LENIS WHAT WE HEARD FACILITY S. PARKS

SETTING THE DIRECTION COMMUNITY ENGAGEMENT

SUMMARY

DRAFT FACILITY SCHEMATIC DESIGN: GROUND LEVEL

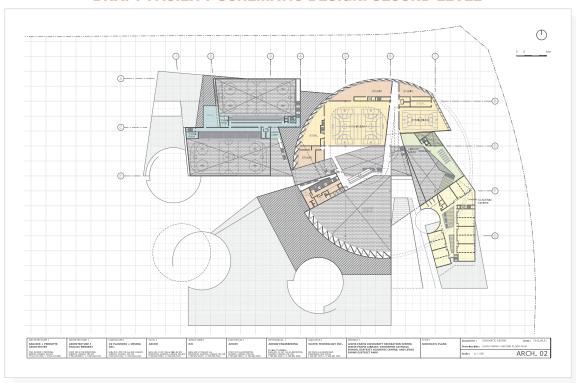
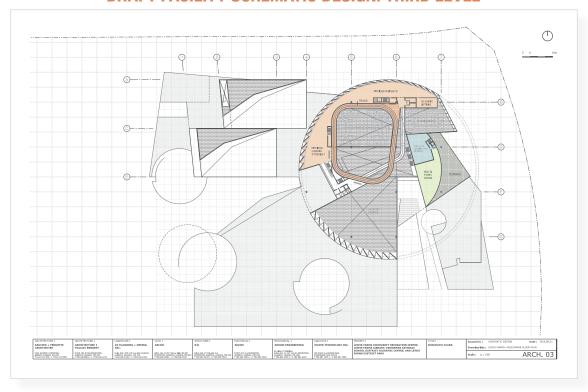
- There is a high level of satisfaction with the draft facility schematic design.
- It was suggested that the 53m pool be included in the facility.
- The grouping of the fitness centre on one level is considered good.
- The schematic design meets the needs of the community.

- The facility should include the 53m pool.
- The design is good and includes the necessary activity areas.
- The design is efficient and has lessened the amount of wasted space.
- Gathering the fitness spaces on one level is good.

- Traffic planning is needed to ensure the area roads can accommodate the increase in traffic due to the facility.
- The parking layout needs improvement. Entrances are far from parking.

- The current fitness space is insufficient and should be larger.
- Additional parking is needed and should be closer to entrances.
- The larger pool is not a community amenity—the smaller pool is good.

- The new facility needs to include the 53m pool.
- This facility supports community need—everything is included. There is anticipation for the opening
 of the facility.
- The facility looks well thought out and very functional.
- Including the 53m pool will lessen the demand on the Kinsmen Aquatic Centre.
- The grouping of the fitness area is good design. Having the fitness and track on the third level is good.

- The facility needs the 53m pool.
- The design has too much wasted space. There is too much emphasis on the design.

- Meets overall objectives an incorporated a lot of feeback.
- Flow and layout look good.
- The option of gender specific and universal change rooms is good.

• Main floor multipurpose rooms should be convertible into one large space or several smaller spaces.

- The gym on the second floor could be noisy beneath it and cause supervision problems.
- · Pool storage seems lacking.

During Setting the Direction we heard support for the layout of the facility, however, there was more circulation space than necessary in the design so approximately 8,000 m2 of space was removed to avoid overbuilding.

DRAFT SITE SCHEMATIC DESIGN

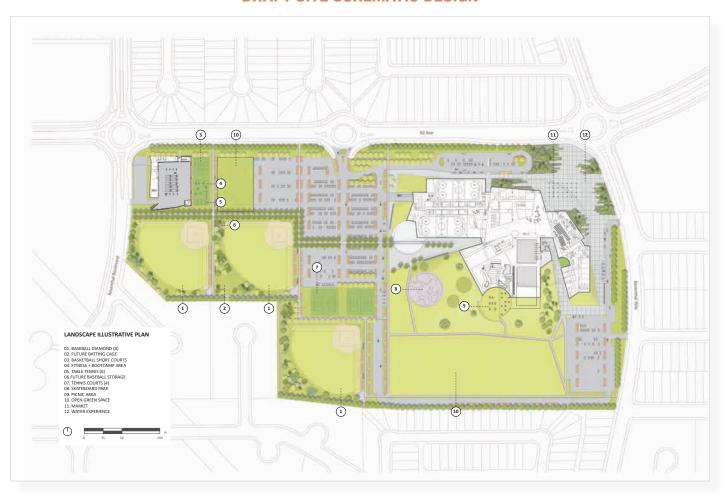
- There is a high level of satisfaction with the draft site schematic design.
- It was felt that the 53m pool should be included.
- There are concerns about parking: sufficient amount, distance from the facility.
- The inclusion of a soccer field and outdoor playground were identified as desired elements.
- The site design has been identified as meeting community need.

- Good job with the design.
- The larger pool should be included as part of the design.

• There are too many ball diamonds in the design.

- An outdoor playground is needed on site.
- · Parking is too far from the facility.

- The 53m pool is an essential component.
- The design is good and makes good use of the space.
- A soccer field should be added to the site.
- The design accommodates a lot of activities.
- The amount of parking is questionable. It is important to ensure parking demands are met.

- The 53m pool should be included in the facility.
- · A spray park is needed as is a playground.

- The 53m pool is needed in the facility.
- There are too many ball diamonds on the site.
- · A soccer field is needed.
- The site shows too much green space.

- Good variety of spaces.
- The inclusion of the water features is questionable.
- A lot of green space. It may need to be programmed or naturalized.
- Meets community need.

- Viewing areas should be considered for outdoor elements.
- Connections between inside and outside elements need to be emphasized.
- · Natural elements in landscaping could provide placemaking impact.

- · Site layout is more linear than building
- Main entrance is away from most parking.
- · Change area near water play area is needed.
